TO: Mercedes-Benz Dealer Principals, General Managers, Sales Managers, Service	FROM: Gregory Gunther, Department Manager, Vehicle Compliance and Analysis,
Managers, Parts Managers	Engineering Services
RE: Recall Campaign Launch Notification	
Check Second Row Seat Track Alignment	Date: October 16, 2020
MY20 247(GLB-Class)

Recall Campaign Bulletin

Campaign No. 2020090020, October 2020

SUBJECT: Model GLB-Class vehicles (247 platform) Model Year 2020 Catch Mechanism Second Row Seat

Figure 3

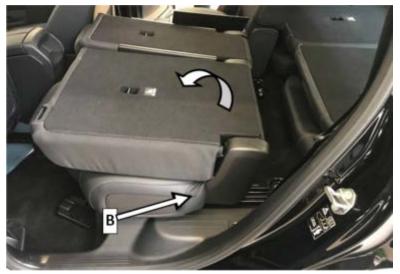
- 13. Actuate adjustment lever for fore/aft adjustment and slide seat frame base forward all the way to the end stop.I The adjustment lever is located at the front under the seat surface.
- 14. Tighten rear screws of seat frame base.

i First tighten inner screw onto seat frame base, then tighten the outer screw.

Mm Seat frame base on bodyshell **50 Nm**.
